Review 1

Preliminary and Final Major Site Plan

Application P-25-026

361-373 John F. Kennedy Boulevard Redevelopment Plan

Illustration 3. Architectural Elevations of Side (left) and Rear (right) of Proposed Building

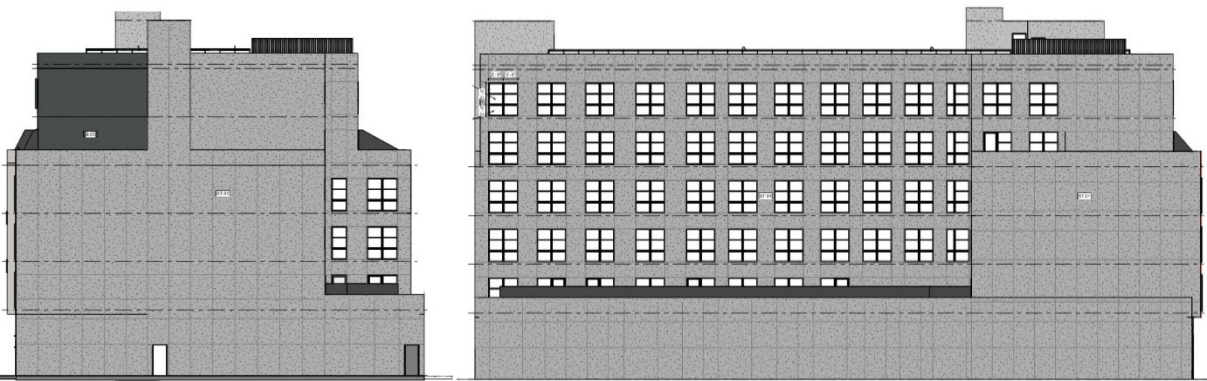
- 9.4. **Blank Walls.** Pursuant to §6.2.E.3, all building façades shall be designed to be attractive from each vantage point and be consistent in their quality and finish on all elevations. §6.2.E.5 prohibits blank or featureless walls. No buildings shall have a wall with an uninterrupted length of more than 60 feet without including any change in the vertical plane of the façade. The street-facing façades are designed to be consistent in the quality and finish, however the side and rear façades are plain, blank walls with the rear façade extending nearly 120 feet without a change in the vertical plane. **Does not comply.**
